Re: Experimental Station WB9XVP (File No. 0136-EX-ST-2004) At Cottonwood (Yavapai County) Arizona; Broadband Over Power Line System; Evaluation and Critique of 6-Month STA Report.

Analysis of Electric Broadband 6-Month Report, Experimental Authorization WB9XVP

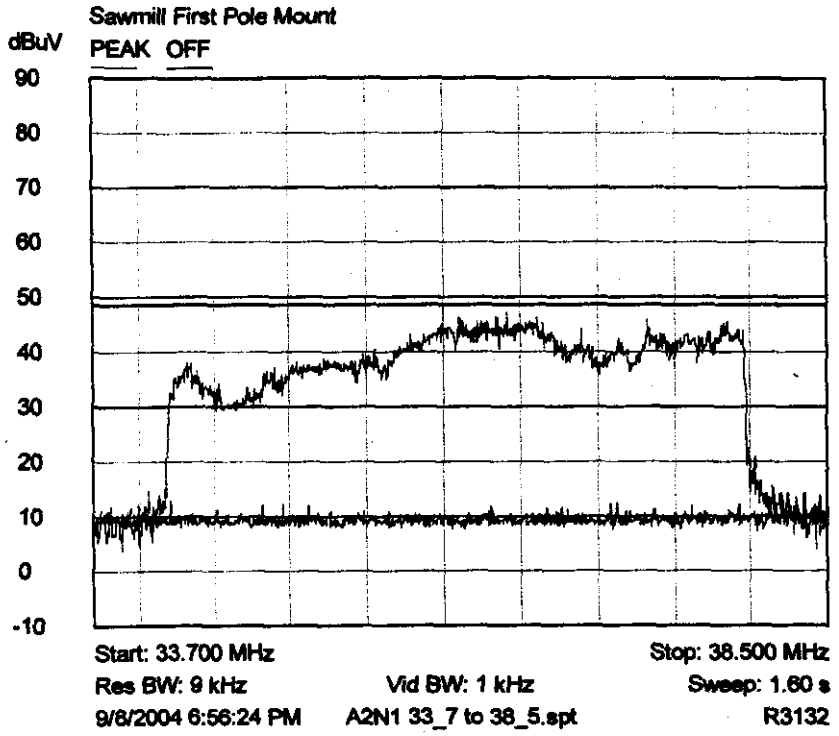
In their 6-month report, EB claims that their tests indicate that this system complies with the FCC limits, but their own test data compel a different conclusion. Although not directly related to amateur interests, ARRL notes that the emissions limits on 30-50 MHz are being significantly exceeded. This is a band actively used in Arizona by public safety organizations.

Figure 1: This figure from Page 20 of EB's report shows the measured levels between 33 and 38 MHz at the Sawmill test area, "first pole mount." These data were presumably taken at the same 10-meter horizontal distance that EB states was used for all of its testing. The emissions limits on this frequency are 100 uV/m at 3 meters distance. On this frequency range, Part 15 regulations call for a 20-dB/decade distance extrapolation. C63.4 also stipulates that a quasi-peak measurement in a 100 kHz bandwidth must be used on this frequency range. This test was done using a peak detector in a 9 kHz resolution bandwidth, using a 1 kHz video bandwidth, not extrapolated for distance. At 10 meters distance, the extrapolated emissions limit is 35.6 dBuV/m. It is impossible to accurately predict the effect of the incorrect resolution bandwidth and video bandwidth, but the worst-case estimate is that this will under measure the field strength by 10*log10 (100 kHz/1 kHz), or by a factor of 20 dB. Suffice it to say, the error is at least 10*log10 (100 kHz/9 kHz), or 10.45 dB. According to their own test data, this system exceeds the Part-15 emissions limits by approximately 19 to 28.5 dB on these frequencies. This correlates well with the strong signals in this frequency range as observed by the Cottonwood-area amateur licensees.

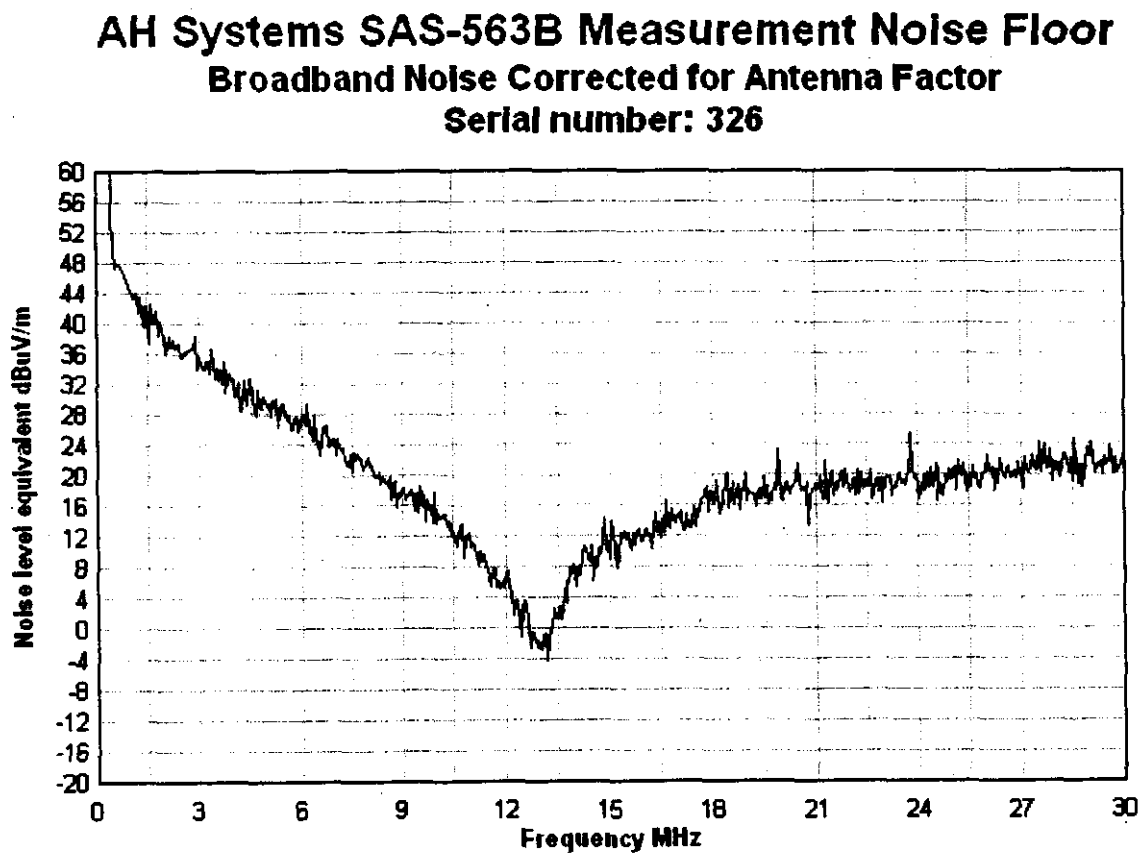
Figure 3: This figure shows the noise floor of the antenna and HP-8653B spectrum analyzer, corrected for antenna factor. This is the minimum sensitivity of the test equipment, and measurements cannot be made below this level. While ARRL's specific serial number is a bit different than the one used by EB, this test-fixture noise floor corresponds well to the levels reported by EB and APS as "ambient noise levels." Their results may be the ambient noise levels of their test fixture, but the relative noise levels made by amateurs using their receiver signal-strength meter readings show that the ambient noise level in the area is much lower than what was reported by EB and APS. A simple analysis of the specifications of the test instrumentation explains their results and incorrect conclusion.

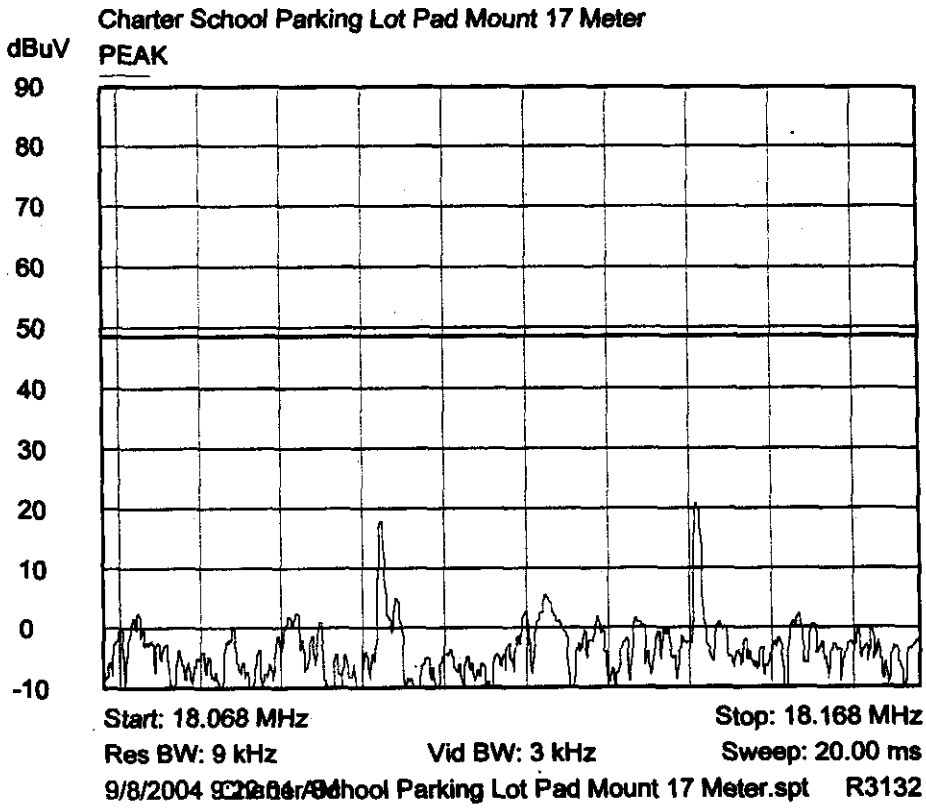
Figure 4: This shows the ambient noise level on the 17-meter amateur band. In stark contrast to EB's claim that the ambient noise levels were high at their test locations, these data show an ambient noise level below -10 dBuV/m. This corresponds well to the low noise levels measured by ARRL in its testing of ambient noise levels made in another part of the country. Of note, on 18 MHz, the antenna factor of the AH Systems SAS-562B is typically about -20 dB. This corresponds to a gain of 15.3 dBi.

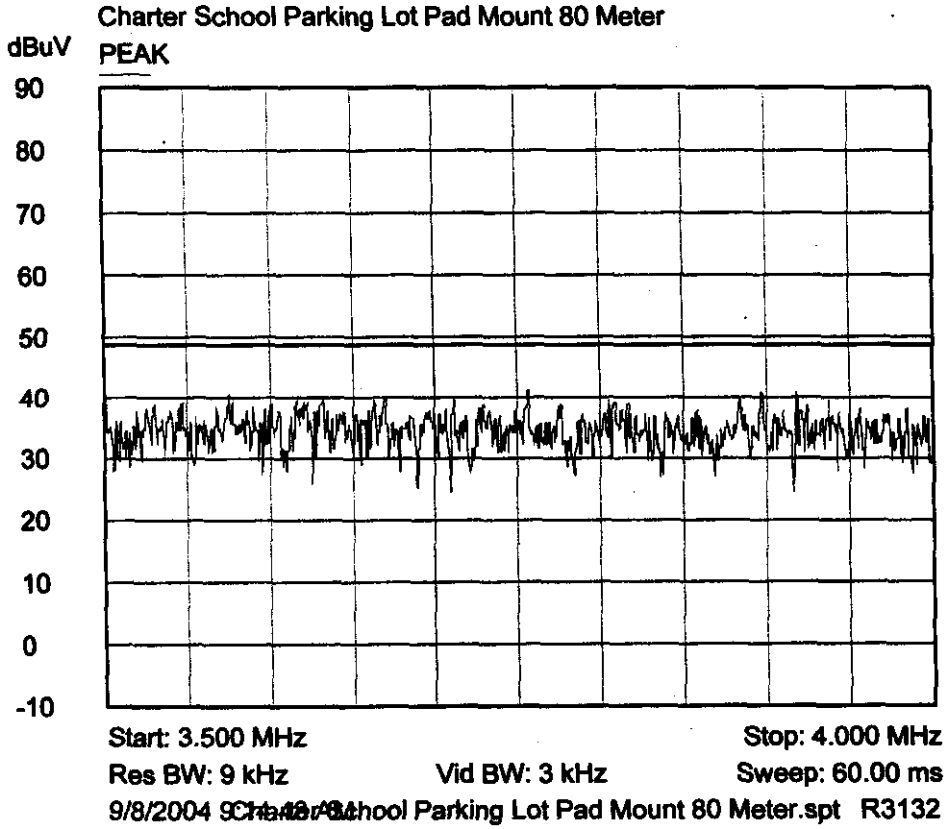
Figure 5: This shows the reported measurements on the 80-meter amateur band. The typical antenna factor of the SAS-562B is +28 dB on 3.5 MHz. This is 48 dB higher than the antenna factor on 18 MHz, and not surprisingly, most of this difference shows on the noise level seen on this graph. This graph shows the noise floor of the test fixture, not the much lower ambient noise level to be expected on 3.5 MHz in a typical residential environment.

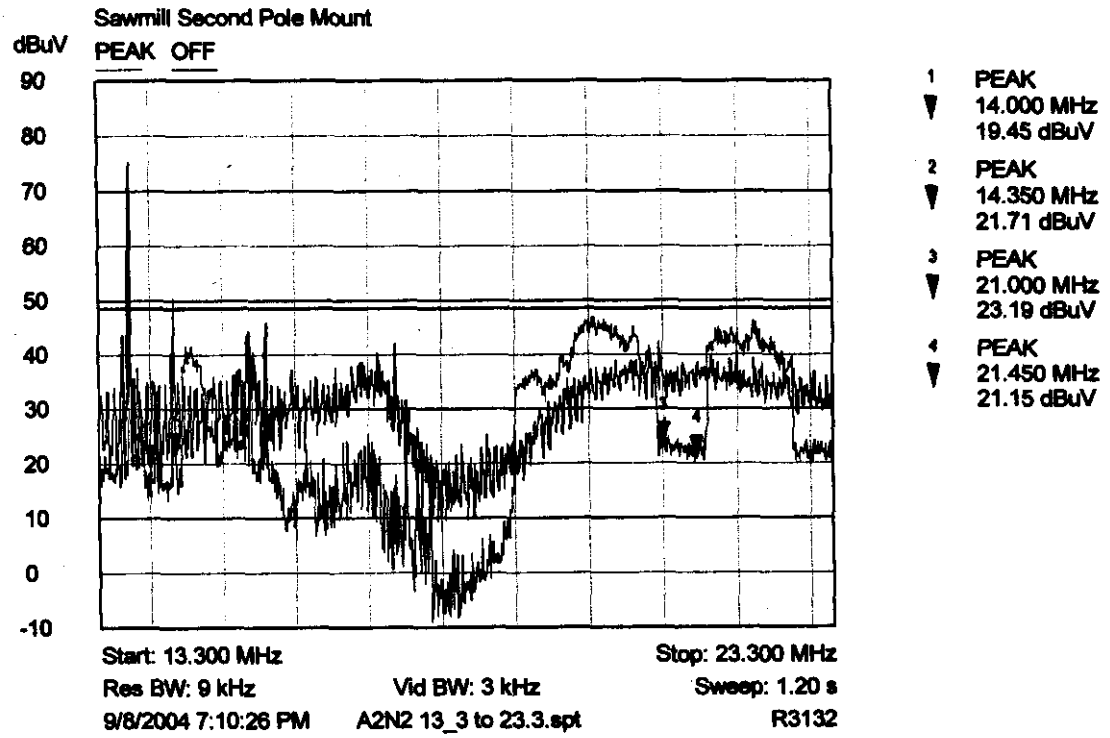
Figure 6: This graph purports to show the measured levels with the BPL system on and then off between 13 and 23 MHz. Green shows the BPL system and red shows the BPL system off. If these data are accurate, one would have to conclude that turning the BPL system reduced the ambient noise and signal levels by 20 dB across part of the frequency range being measured. Most dramatic is the notch that is shown between 21 and 21.45 MHz. The ambient conditions on this spectrum are shown to be 35 dBuV/m, yet when the system is turned on, these data show that a measurement can somehow be made 15 dB below this level. If the measurement of ambient levels is correct and the bandwidth between the two measurements is the same, the only way this ambient-level-vs measurement-level can be reconciled would be to increase the level of the BPL-measurement line (green) until the ambient noise levels in the notched spectrum match. If this were done, however, the BPL signal would increase a corresponding amount, and would thus exceed the Part-15 emissions limits by a considerable margin. The notching in the ambient and BPL-signal data is a representation of the antenna factor data programmed into the analysis software used to capture and display the spectrum-analyzer information.

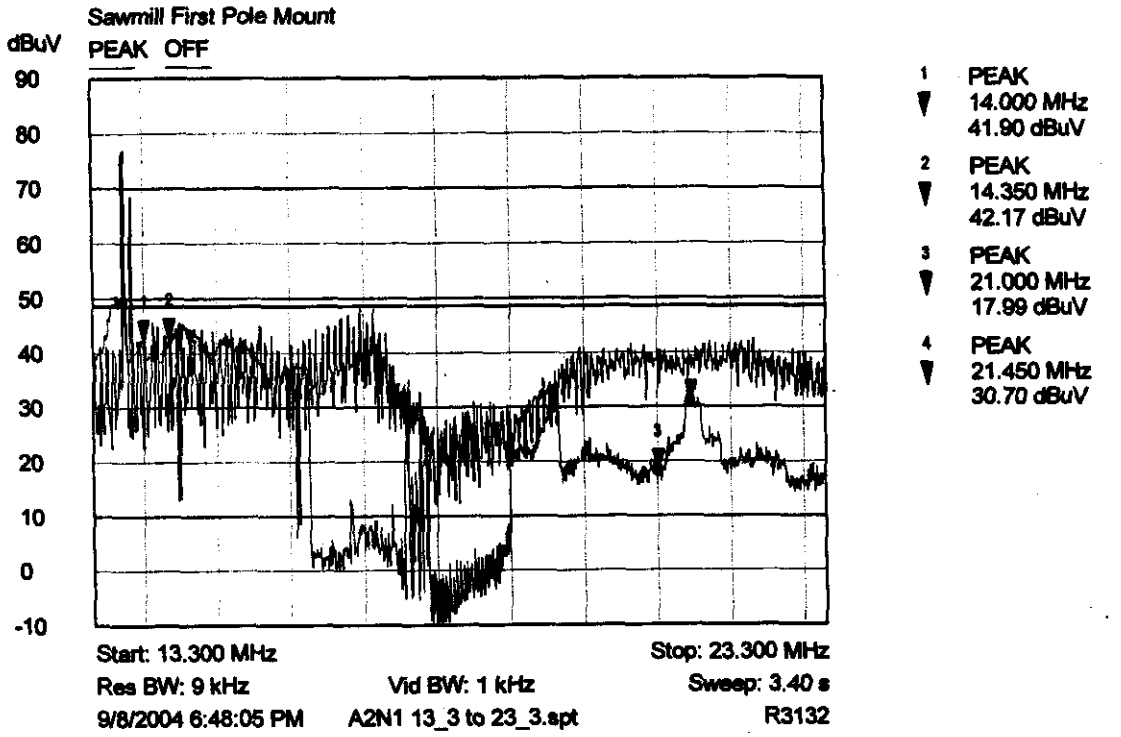
Figure 7: This graph shows the same problem, at a different test location. In this case, the apparent decrease in ambient signal and noise levels is about 30 dB in part of the spectrum. If these data were presumed to be correct, turning the BPL system on would be having the impossible effect of dropping the noise level in the spectrum it uses by 30 dB. This graph also shows that Based on the difference in the amount of noise shown on each line, it is possible that the bandwidth was smaller for the "BPL on" measurement or different analyzer reference level settings were used for each of the data lines shown in this graph. It is not possible that turning on a BPL signal would decrease the ambient noise levels by 30 dB. If the BPL data were increased by 30 dB to match up the ambient noise levels, the BPL signal would exceed the FCC Part-15 emissions limits.

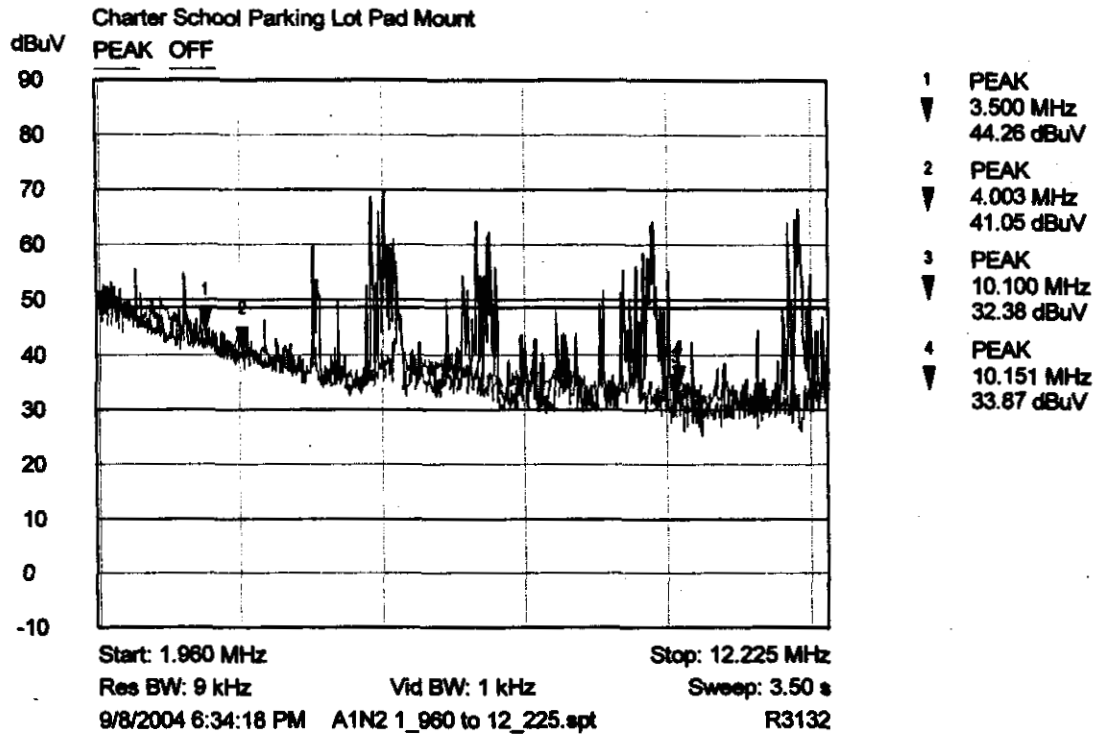
Figure 8: In this graph, on spectrum that the BPL system does not appear to be using at this location, the ambient noise levels match up. However, the graph with the BPL system "on" does not show most of the much stronger ambient over-the-air signals seen on the graph of the BPL system off. If these data were taken at the times indicated with the same test conditions, the stronger ambient signals levels would have been approximately the same in both graphs. The presence of the BPL signal would not have reduced the level of all of the ambient signals propagating to the area at that time. Incidentally, Most of the ambient noise in this frequency range shows the lower limit of the test fixture, not the level of the local ambient noise levels in between the on-the-air signals.

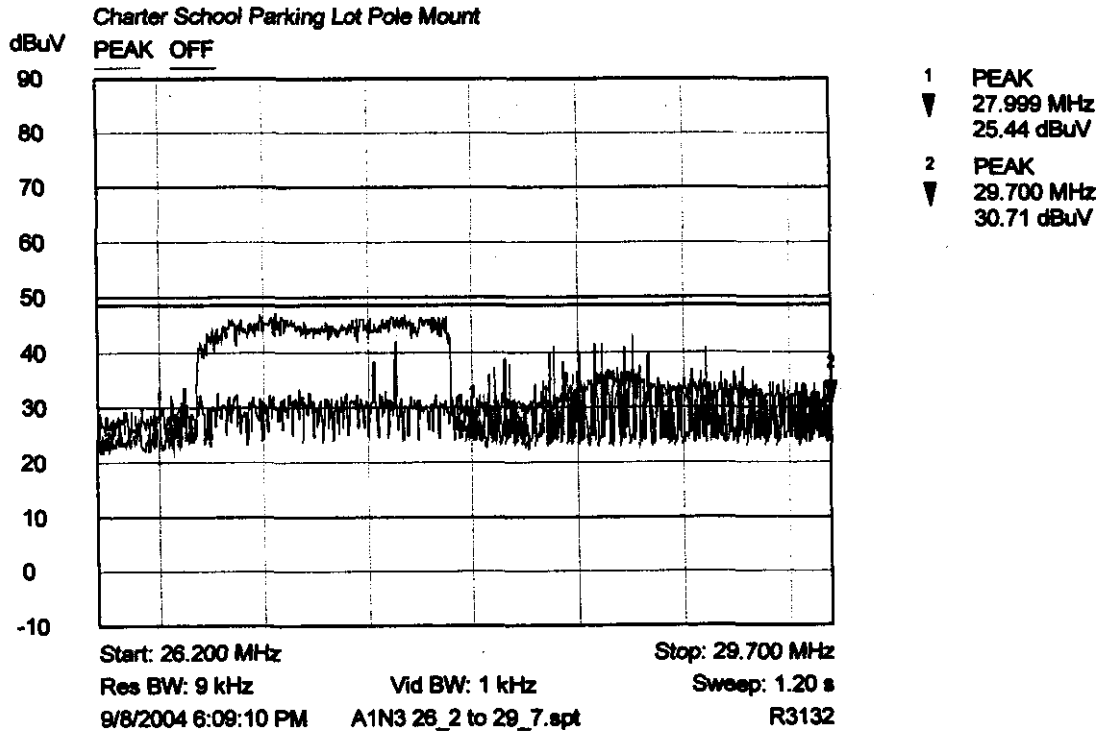
Figure 9: The EB report indicates that no BPL signals were present in any amateur band. This graph, however, shows the BPL system on with the green line and the BPL system off with the red line. It is clear that there are strong signals present – above 40 dBuV/m in some case – in the amateur band when the BPL system is operating. At 40 dBuV/m, these would be typically reported by licensees as "S9" level signals, very strong compared to the weaker licensed signals that are typical on this spectrum. If the ambient noise levels were set the same on both data sets shown in this graph, the BPL "on " signal would increase by a corresponding amount. As shown in an earlier section of this document, their reported "ambient" levels really show the noise floor of their test fixture. The BPL signals in the 28-29.7 MHz amateur band are well above the ambient noise level seen in that spectrum.
